# PLANNING COMMITTEE REPORT

<b>APPLICATION FOR CONSIDERATION:</b>	<b>STARCROSS - 17/02727/FUL - Brickhouse Farm Barn, Mamhead - Conversion of storage barn to wedding/function venue including new access track, associated parking and landscaping</b>	
<b>APPLICANT:</b>	<b>Mr &amp; Mrs Szczepura</b>	
<b>CASE OFFICER</b>	<b>Claire Boobier</b>	
<b>WARD MEMBERS:</b>	<b>Councillor Connett</b>	<b>Kenton With Starcross</b>
<b>VIEW PLANNING FILE:</b>	<a href="https://www.teignbridge.gov.uk/planning/forms/planning-application-details/?Type=Application&amp;Refval=17/02727/FUL&amp;MN">https://www.teignbridge.gov.uk/planning/forms/planning-application-details/?Type=Application&amp;Refval=17/02727/FUL&amp;MN</a>

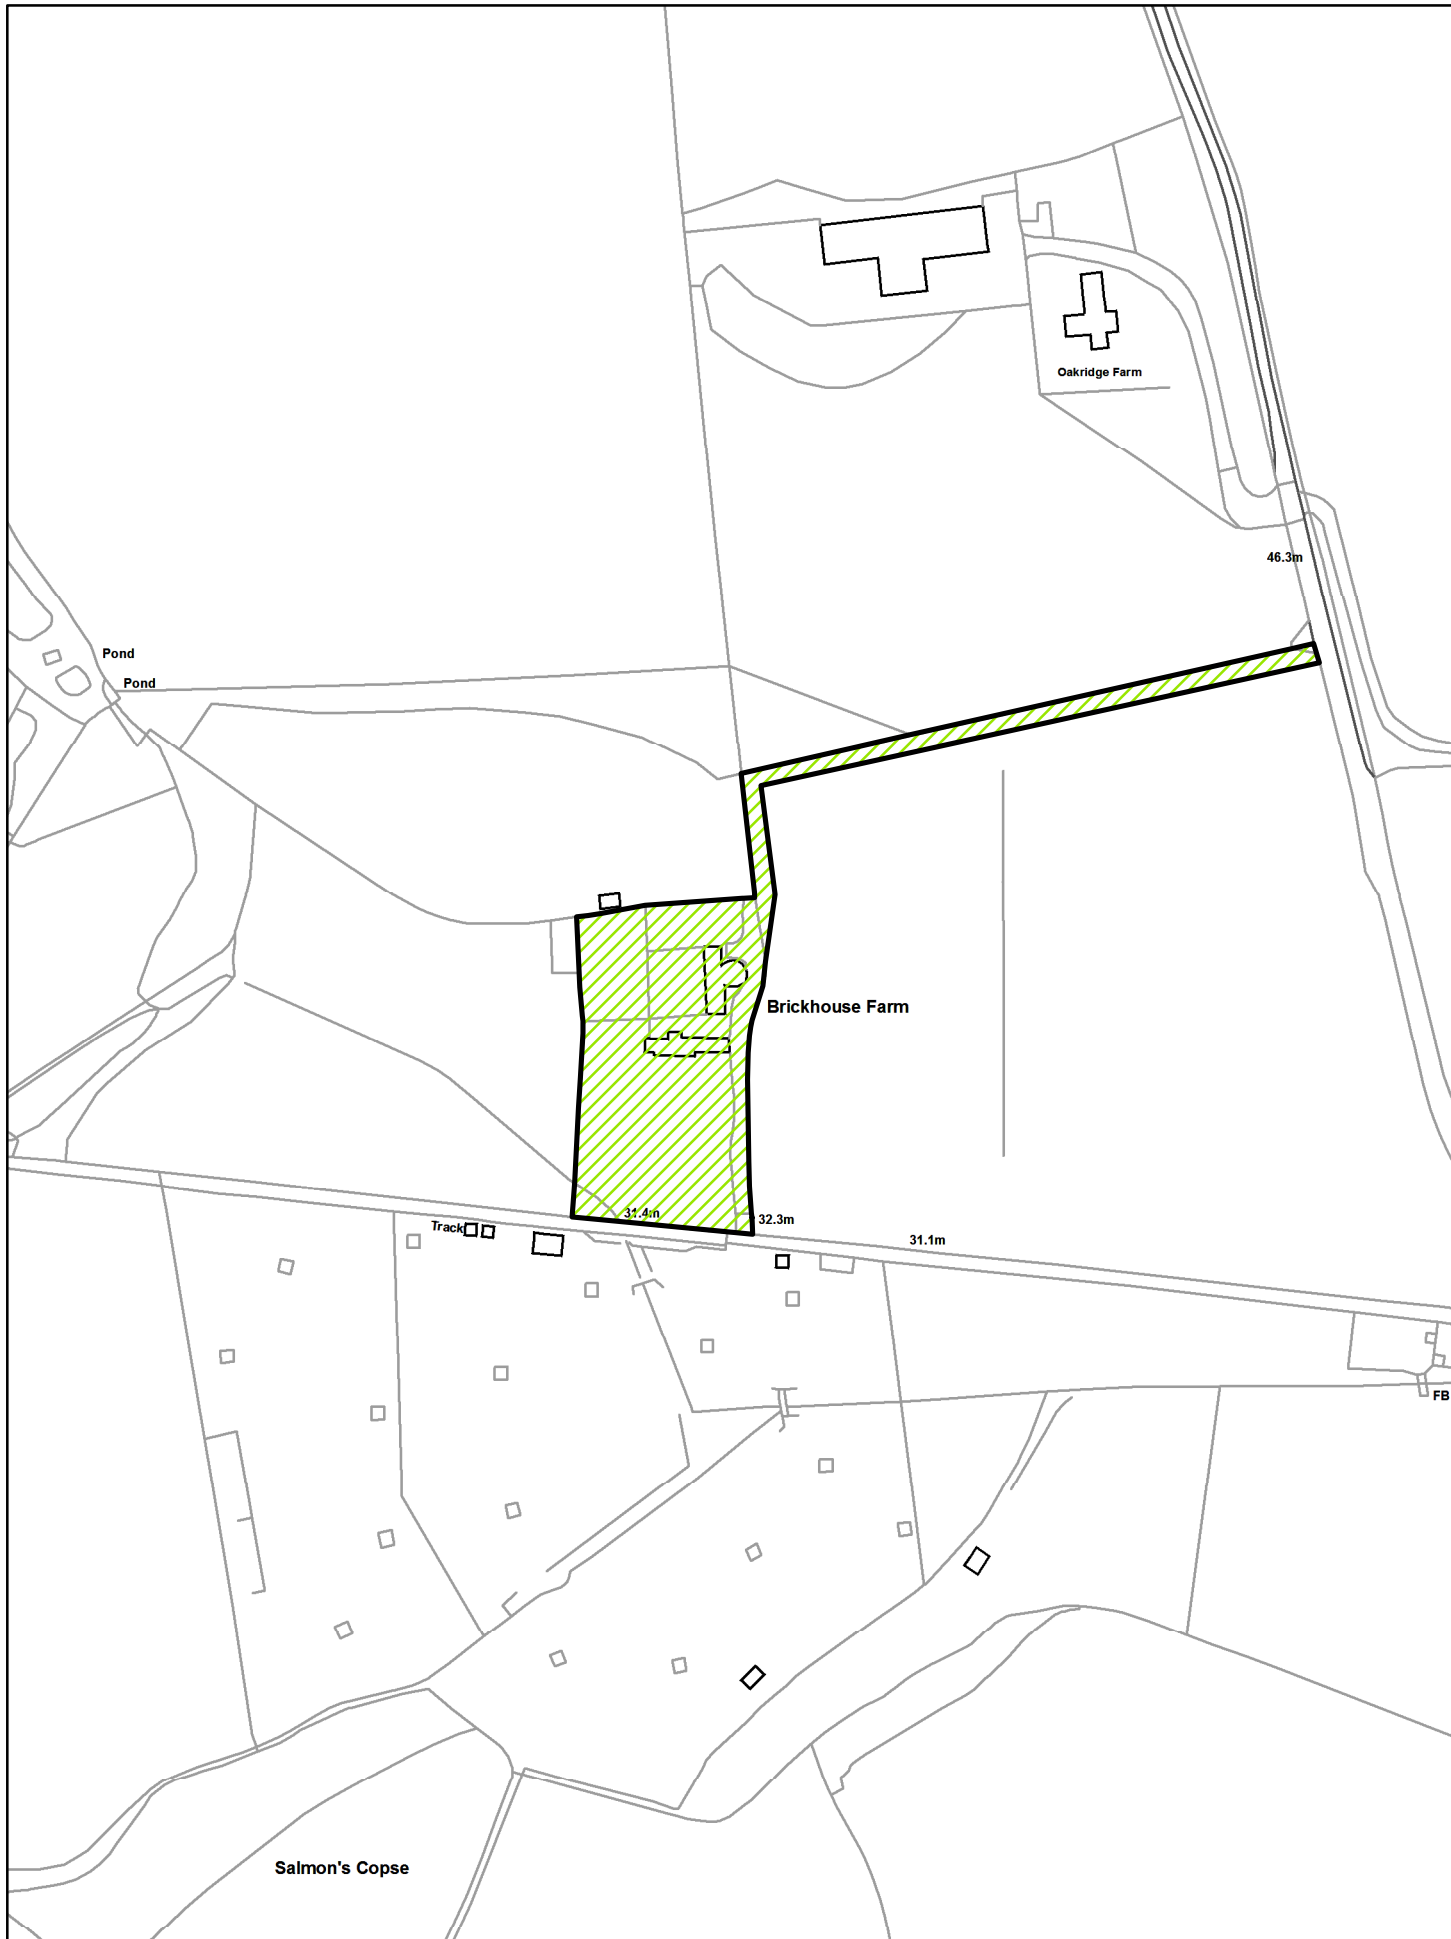
The proposed development would be likely to result in a material increase in the volume of traffic entering and leaving the Class C County Road through a junction which does not provide adequate visibility from and of emerging vehicles, contrary to paragraph 32 of the National Planning Policy Framework and Policies S1A and S1 of the Teignbridge Local Plan 2013-2033.

- 3.18 However, there are some areas of the scheme which would harm the listed building and should be altered. It is proposed to install a canopy above the first floor window on the north elevation. This element of the scheme would cause damage to the brickwork by fixing the canopy to the barn and is not a feature which is complimentary to this barn as it is out of character with its agricultural character. If minded to approve, a condition is recommended to state that notwithstanding the submitted drawing, this element of the scheme shall not be installed. With this condition in place it is considered that the internal and external works to the building to enable its conversion subject to details can be undertaken without harm being caused to the listed building.

- 3.22 Regarding the entrance, it is considered that the granite gateposts are inappropriate to the character of the area and the status of the property. It is suggested that square oak posts are used instead. The tops of which could be chamfered off and capped with lead but otherwise embellishments should be avoided. Likewise, an appropriate gate would be a simple wooden field gate, which could also be made of oak, and should reflect the local style. Whilst the scale of the entrance and treatment of the hedge on the entrance is considered acceptable, the entrance has close connection with the public realm and therefore it is important that the details of the type of gate and gate posts to be used reflects the status of the property. It is considered that this concern with the use of the granite gate posts and lack of detail about the gate to be used can be overcome by way of condition, it is recommended that, if minded to approve, a condition be added to state that the granite gate posts shown on the submitted plans are not approved and to secure agreement to an appropriate gate and gate post detail by way of condition to ensure that these treatments are appropriate in the context of the status of the building within the wider landscape in order to ensure that the detail does not undermine the setting of the listed building.

- 3.23 Regarding the drive, it is considered that the proposed character for the new access drive is of too high a status, being set too far from the existing hedge with the processional planting suggesting an avenue which undermines the setting of the listed building and the hierarchical status of the building in the wider landscape. It is recommended that a more appropriate access drive that would preserve the setting of the listed building and its status within the wider landscape would be to move the access drive closer to the hedge, but still at a sufficient distance from it to avoid root damage to the hedge and for standard trees to be positioned within the existing hedge at irregular spacing rather than processional. A native species hedge bank on the south side of the track could be planted if containment of the track is desired without undermining the wider landscape. It is considered,

- 3.24 Regarding the hard detailing around the barn, no objection is raised to the parking layout, however the use of Grasscrete as proposed for the bays is considered to be overly urban in character. It is considered that a more suitable material to be used in a rural location such as this to preserve its rural character would be bound crushed stone, bituminous macadam or similar. It is considered that a more appropriate material can be found to overcome this concern and therefore, if minded to approve, it is recommended that a condition be applied for an alternative material for the parking bays to be agreed to ensure that the setting of the listed building is preserved.

- 3.25 Regarding the stone terrace to the front of the barn and the service vehicle access, it is considered that the sandstone paving proposed for these areas is of too high a status, over-domestic in character and unsympathetic to the character of the listed building. It is suggested that the use of rich materials be restricted to using stone at thresholds only and that bound stone, hoggins or similar would be more sympathetic to the curtilage of the listed building. It is also recommended that an additional screen be provided in the form of a dropped hedgebank positioned along the eastern perimeter of the track/parking/terrace to hide the lowest parts of the elevation and conceal the cars and changed activities from view in the wider landscape as well as resolving the change in level. These alternative materials and additional hedge planting, it is considered, would preserve the setting of the listed building. As it is considered that a more appropriate material/additional planting could be used to address the setting concern raised, if minded to approve, conditions are recommended to be applied to secure details of an additional hedge to be planted and to secure agreement to alternative material(s) for the stone terrace and service vehicle access.

- 3.34 Devon County Council Highways were consulted on this revised Transport Advisory Note and advise that although this is a reduction in vehicle movements and trips from that previously considered, it does not overcome the poor visibility at the Black Forest Lodge junction, and no mitigation has been presented to make this safe and suitable for the additional trips that this proposal could generate. Therefore the recommendation for refusal remains.
